SERVICE BULLETIN – 01/JANUARY 2009

SPR SERIES and SPN 125-255

CHANGES ON GEAR REDUCER TOP CASE

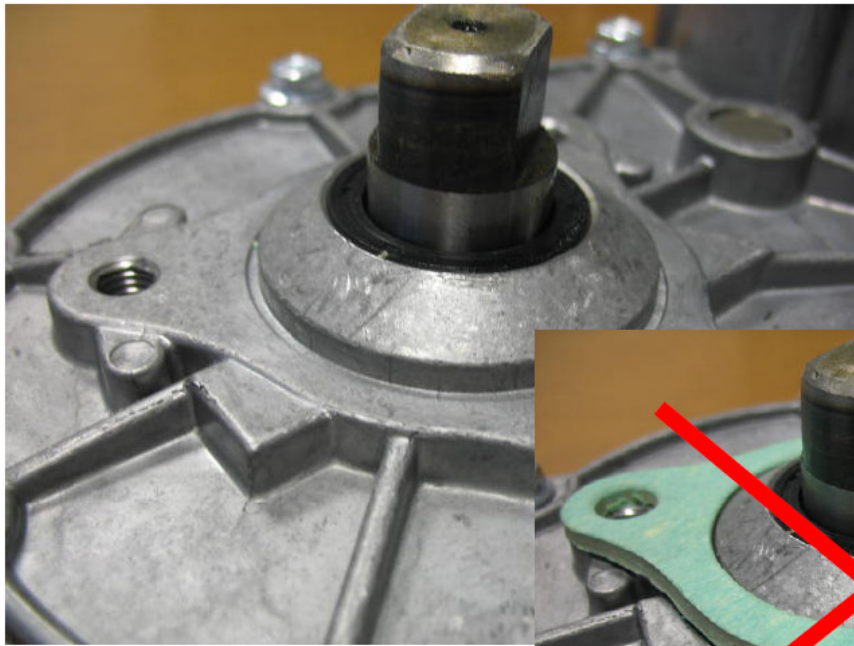
The top gear box case has been modified on their three evaporator/freezer support bases, as detailed on the here below photo, in order to assure a perfect perpendicularity between the gear reducer top surface and the vertical evaporator.

OLD

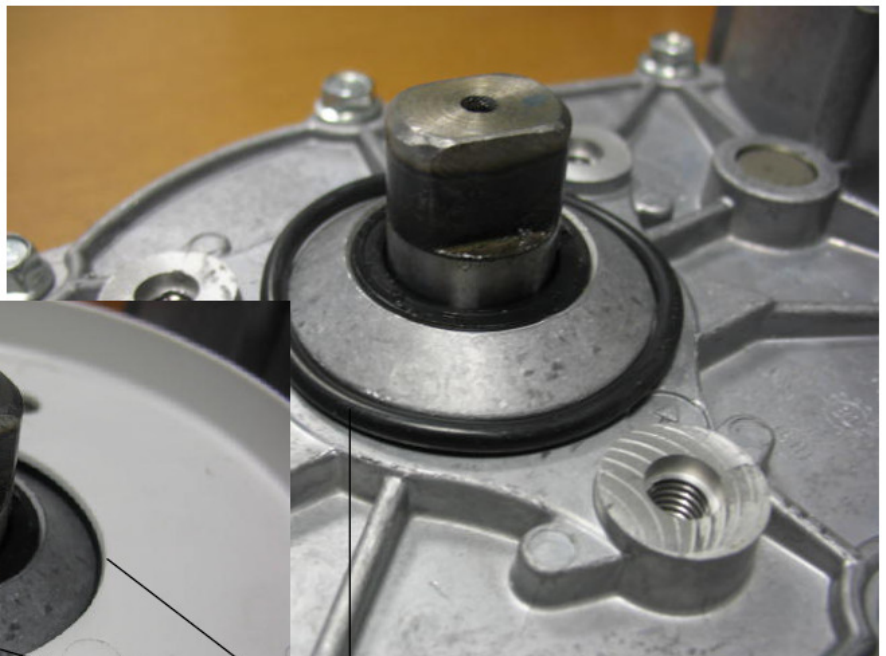
Due to the changes made on the gear reducer top case, the old gasket **P/N 640060 00** is no longer used and has been replaced by an O Ring (**P/N 640041 38**) located between the upper surface of the gear box and the water drip plastic tray.

The new gear reducer, available under the same Part Nbr of the former one, will be supplied completed with the O Ring as well as instruction sheet (attached) once we'll run out of stock of the old version.
